A47 North Tuddenham to Easton Dualling

9.29 Applicant's Written Summary of Oral Submissions at ISH3

**APPLICANT'S WRITTEN SUMMARY OF ORAL SUBMISSIONS
AT ISH3**

Regulation Number:	Rule 8(1)(c)
Planning Inspectorate Scheme Reference	TR010038
Application Document Reference	TR010038/EXAM/9.29
Author:	A47 North Tuddenham to Easton Project Team, Highways England

SECTION H - 'H' OVERVIEW
SCALE : NTS

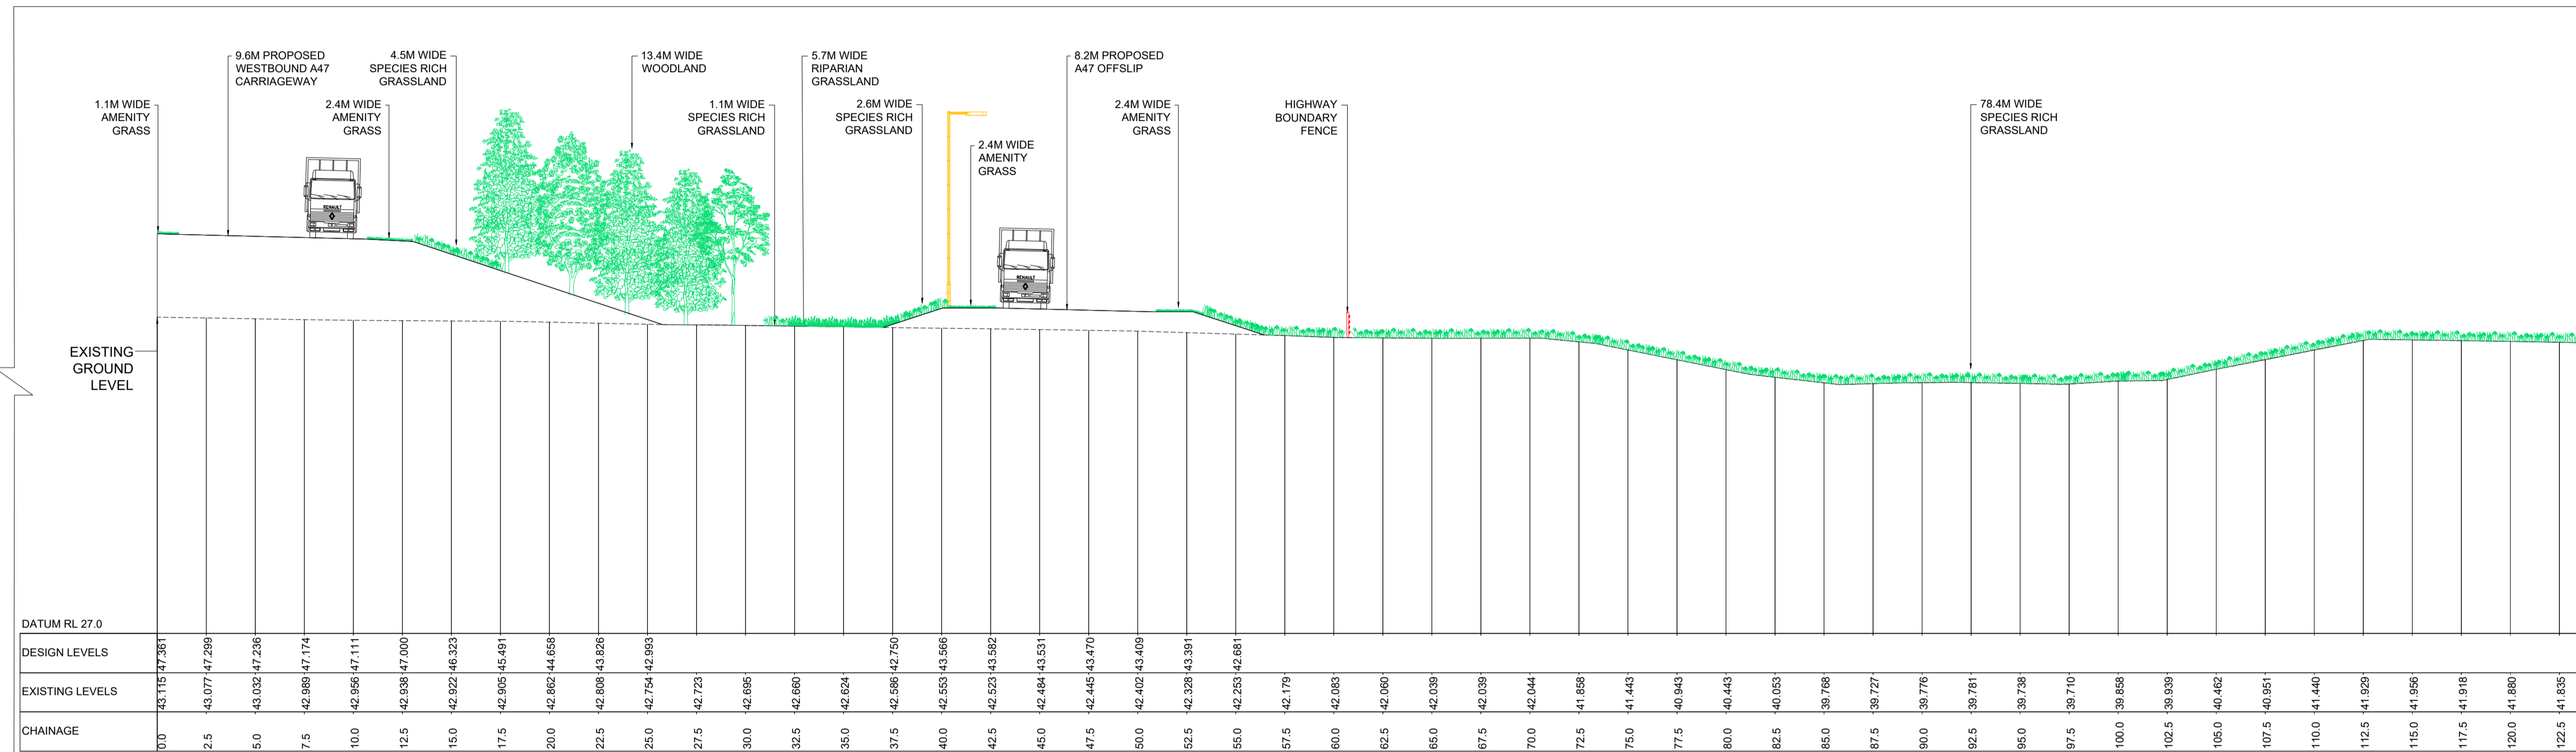
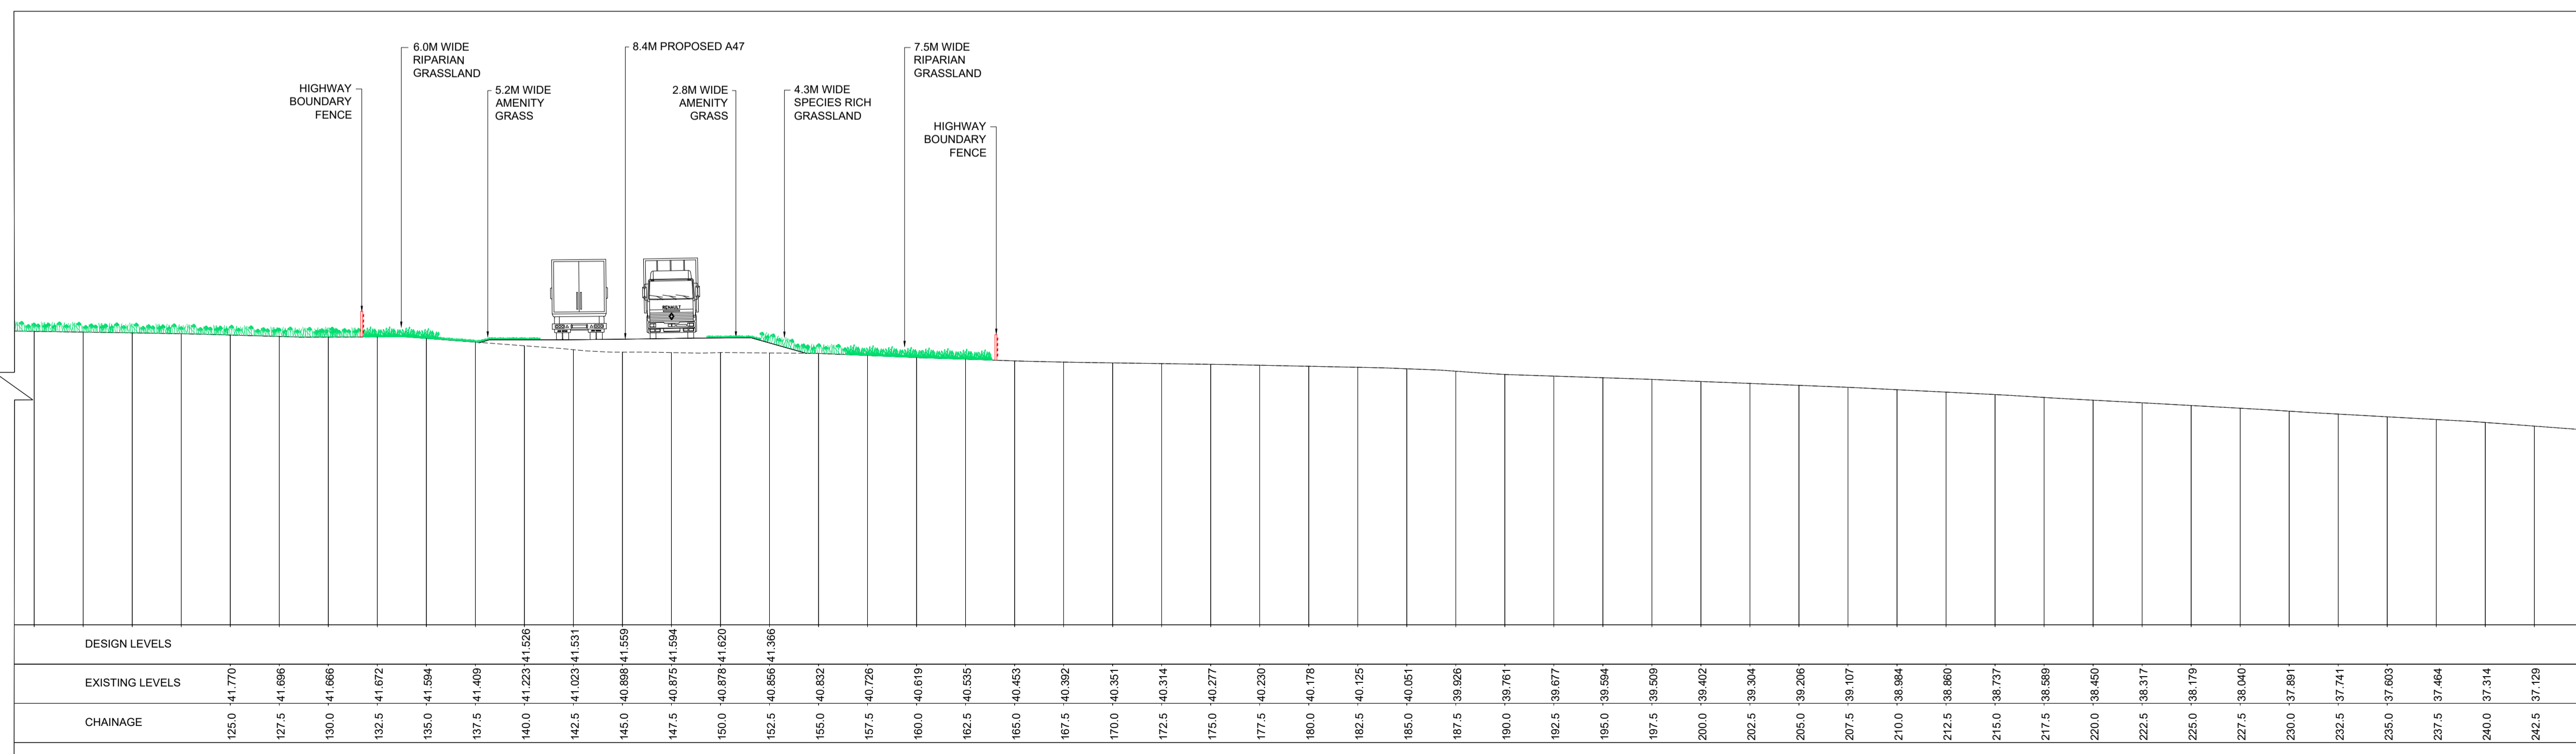
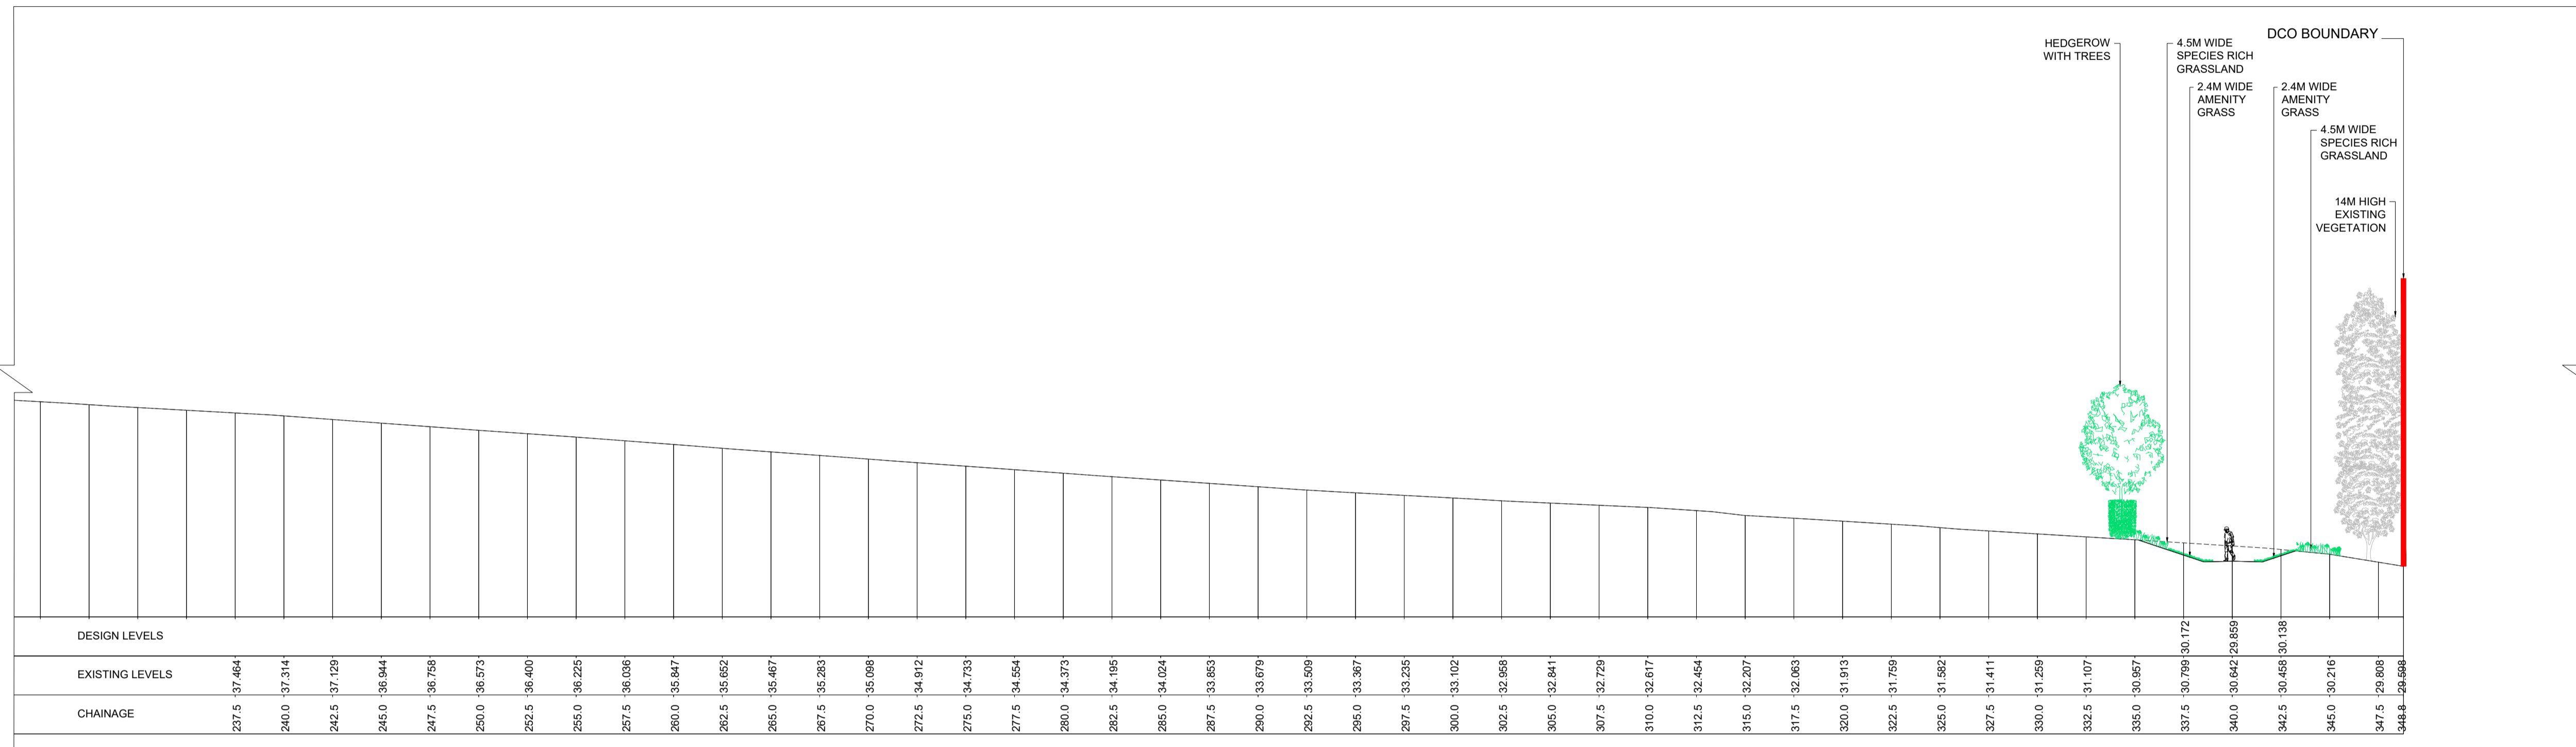
41.	<p>The ExA highlighted a question raised in a previous ISH in relation to the methodology used for cross-sectional drawings.</p> <p>The ExA also queried whether any lighting columns are shown on the cross-sections.</p> <p>George Josselyn asked if it would be possible to delineate the existing trees with those proposed by a change in the colouring and if a line could be drawn showing the limit of the permanent acquisition of land on the cross-section.</p>	<p>The Applicant stated that it would respond in writing to this question with a brief methodology on the preparation of the cross-sections Mr Josselyn referred to.</p> <p>The cross-sections were produced in line with the latest information and data, including topographic data, arboricultural data and the arboricultural masterplan (REP3-016) and are intended to show the scheme planting at a reasonable level of maturity. The existing (retained) trees are shown using data from the arboricultural assessment which makes the retained trees as accurate as possible on the sections.</p> <p>In relation to the lighting columns the Applicant stated that there are no lighting columns that directly dissect the section lines but that the Applicant will include indicative columns within areas to be lit to indicatively illustrate their relative scale and location.</p> <p>In relation to the cross-section drawings the Applicant highlighted that the limit of permanent acquisition is shown by reference to the Highway Boundary Fence. Existing vegetation has also already been annotated on the plans.</p>	<p>Appendix A of this ISH3 hearing note contains updates to the cross-section drawings submitted as Appendix A to the 'Applicant's Response to the Examining Authority's Third Written Questions' (REP6-018). The approach to producing the cross-sections was as follows:</p> <ul style="list-style-type: none"> • The location of the sections was selected to give a range of illustrative material within the vicinity of the proposed junctions and based on a request from the landowners agent for sections at chainages through the road centreline and southwards into Berry Hall Estate. The Applicant reviewed the chainages and provided sections as required including an additional section (Section F-F) not requested by the landowner. • The sections were produced using the Scheme design submitted for Examination, existing topographical survey data and exported from the 3D modelling software.

Ref	Questions / Issues Raised at ISH3 and Hearing Action Points	Summary of Applicant's Response at ISH3	Applicant's Written Response
		<p>The applicant will update the visual representation of existing/proposed vegetation and the freehold boundary in a re-issue of the sections.</p>	<ul style="list-style-type: none"> • The retained existing tree cover is illustrated as accurately as possible, utilising project arboricultural information (refer to APP-094, Appendix 7.6). The height of retained existing trees is represented utilising surveyed heights from the arboricultural report, but does not account for future growth post that survey. • As part of the Scheme, the following key components are also shown: <ul style="list-style-type: none"> - Proposed mitigation planting. Planting information is taken from the Environmental Masterplan (AS-007) and is shown at 8m above proposed ground level, therefore linking to Table 7-6 of EIA Chapter 7 (APP-046) which defines planting heights at Year 15 of operation of the Scheme. - The proposed highway boundary is shown by inclusion of the "Highway Boundary Fence". - Indicative locations of lighting columns are shown at 10m in height, as assessed in the EIA. - Vehicles on the Scheme are shown at a maximum of 4m in height (above road level), the tallest vehicles being lorries.
